## Memphis Housing Authority

### ADDENDUM NO. 2

**Solicitation #CI 17-B-00351**

**For William Foote Homes Board-UP Services**

A-Bldg.

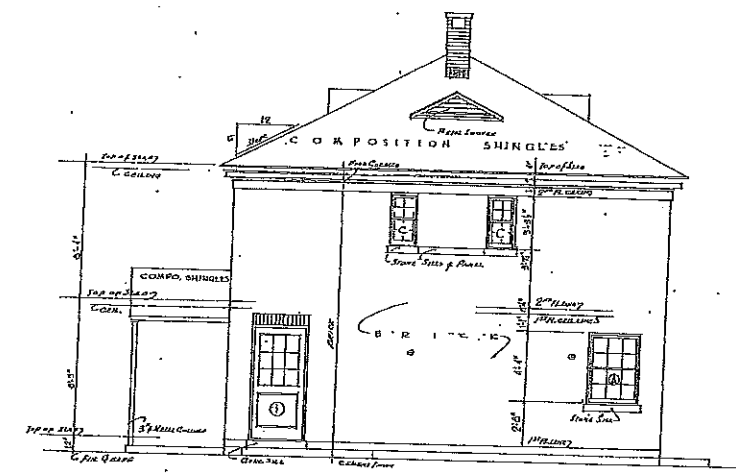
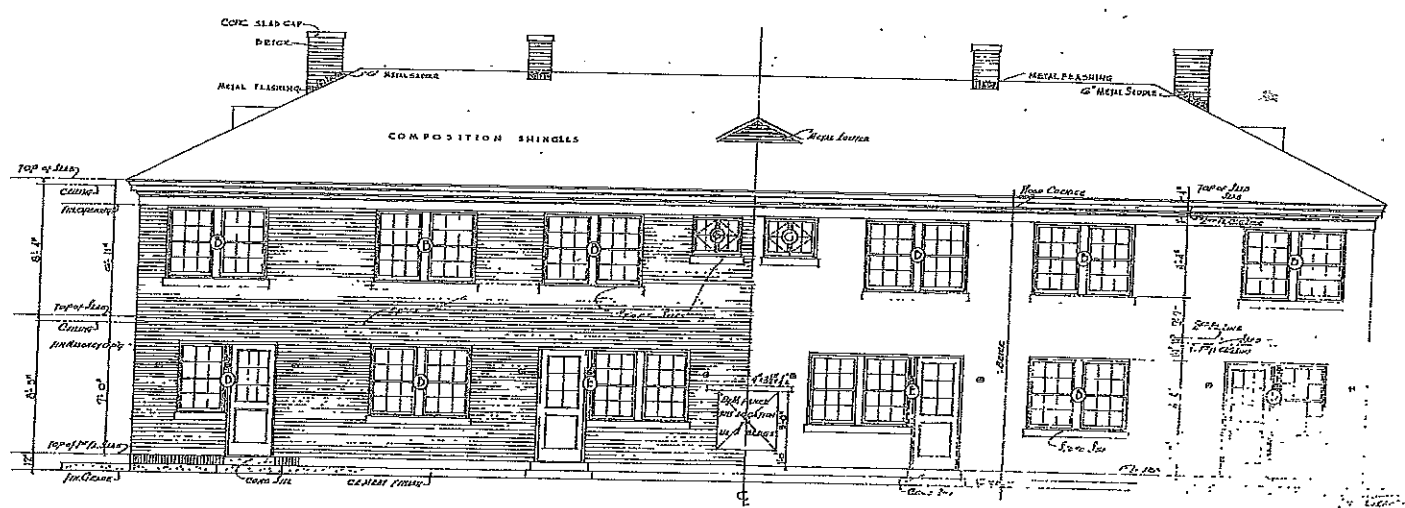
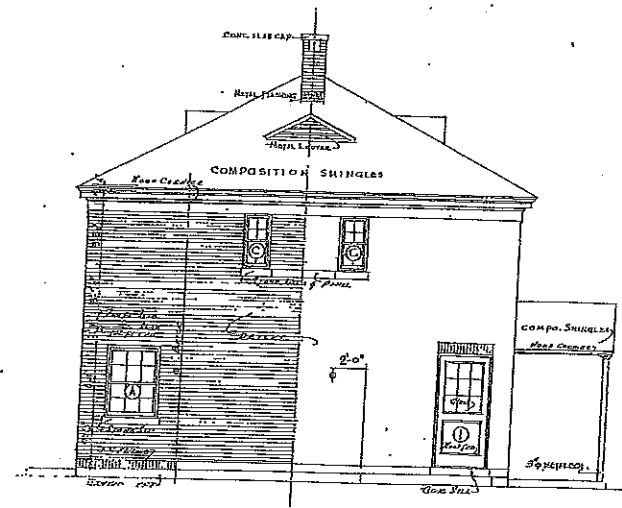
PLEASE DELETE THE INITIAL SITE MAP WITH BUILDING ELEVATIONS of A, B, C and D bldgs. AND REPLACE WITH THE FOLLOW:

- Please see Exhibit-A1, A2, A3 and A4 that depicts revised elevations of the window and door location/bldg.- type.
- Please Note: Number of buildings and windows and doors must be field verified by contractor.

- All First floor windows and doors are to be boarded up
- The (Only) second floor windows to be boarded --UP are the ones above the front and rear entry canopies (see attached building elevations).

☐ upstairs windows to be Boarded-up (ONLY)
